AMERICAN POWER CONVERSION

DESCRIPTION	SB207 CIRCUIT BOARD SCHEMATIC		SHEET	1 OF 3
PRODUCT	MINI 250/400 BACK-UPS		APCC PART #	OS-207
DATE	3/15/91	BY	ESM	SCALE
				DWG
				REV
				12

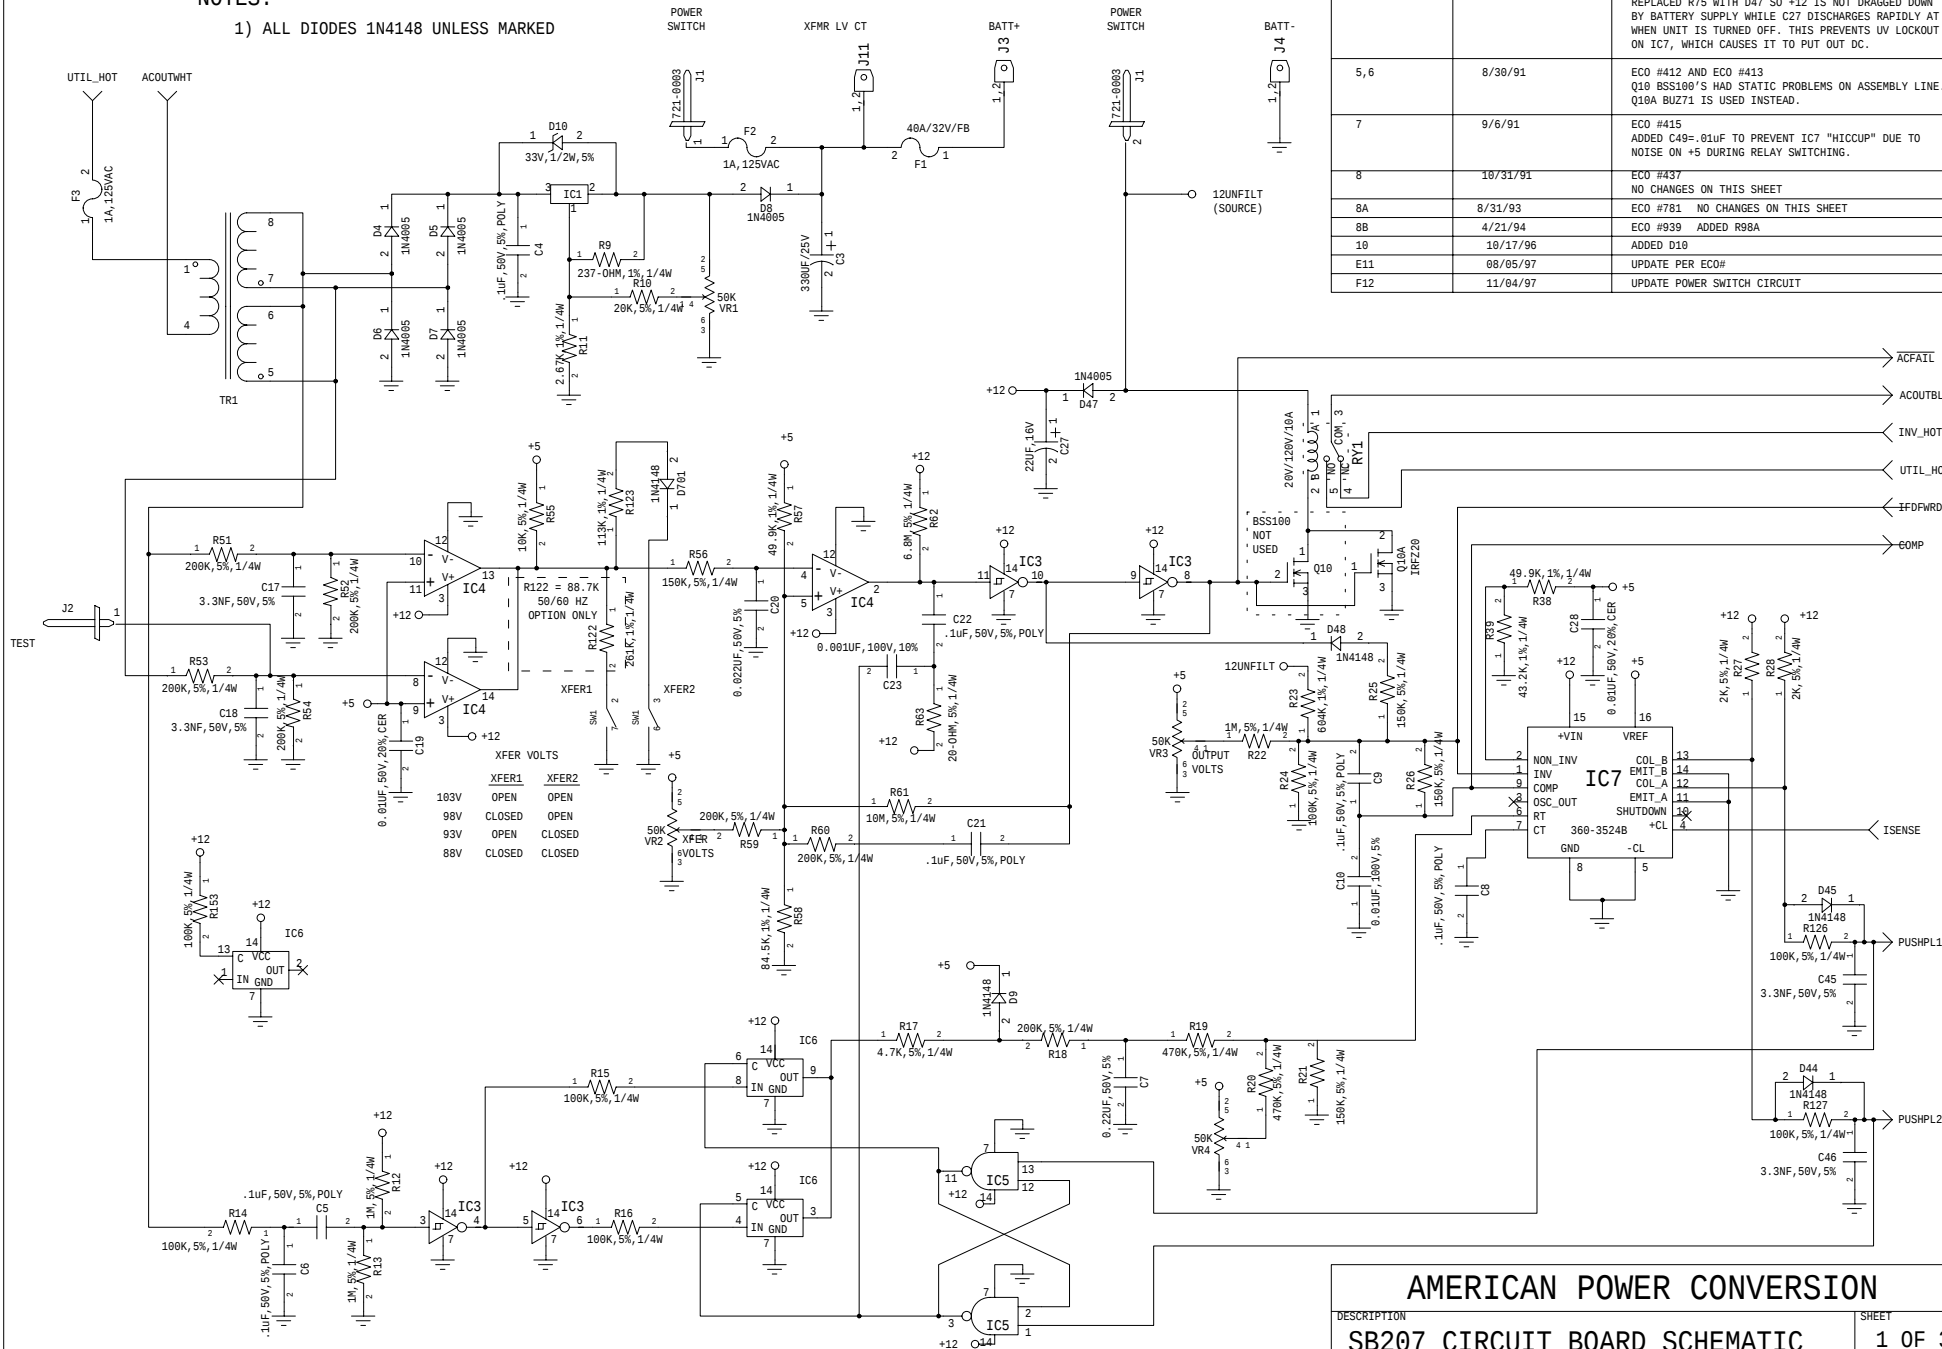
REV #	DATE	REVISION
4	7/17/91	ECO #391 AND ECO #394 REPLACED R75 WITH D47 S0 +12 IS NOT DRAGGED DOWN BY BATTERY SUPPLY WHILE C27 DISCHARGES RAPIDLY AT WHEN UNIT IS TURNED OFF. THIS PREVENTS UV LOCKOUT ON IC7, WHICH CAUSES IT TO PUT OUT DC.
5,6	8/30/91	ECO #412 AND ECO #413 Q18 BSS108'S HAD STATIC PROBLEMS ON ASSEMBLY LINE. Q18A BUZ71 IS USED INSTEAD.
7	9/6/91	ECO #415 ADDED C49=.01uF TO PREVENT IC7 "HICUP" DUE TO NOISE ON +5 DURING RELAY SWITCHING.
8	10/31/91	ECO #437 NO CHANGES ON THIS SHEET
8A	8/31/93	ECO #781 NO CHANGES ON THIS SHEET
8B	4/21/94	ECO #939 ADDED R98A
10	10/17/96	ADDED D10
E11	08/05/97	UPDATE PER ECO#
F12	11/04/97	UPDATE POWER SWITCH CIRCUIT
